Cecilia Valley Elementary

Construction Update

ARCHITECT'S FIELD REPORT

RE: Cecilia Valley Elementary School
Elizabethtown, Kentucky
SCB Project No. 1429

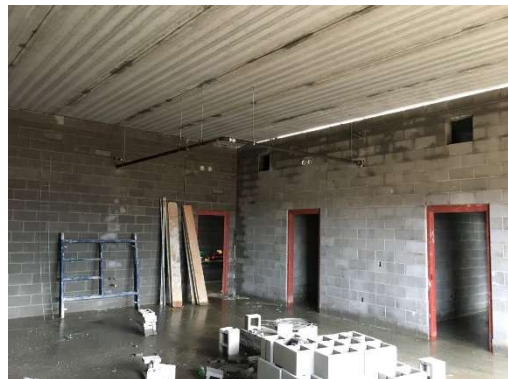
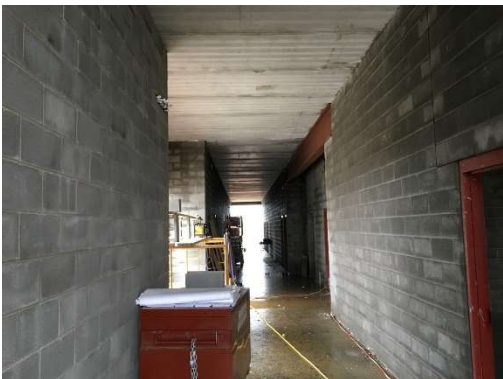
3. Jim Percy indicated to Tim Gupton the soil on the new bus entry from the road needs to be removed and only crushed stone is to be placed at this drive in particularly where the storm drain passes below the drive, as the drain pipe is plastic.
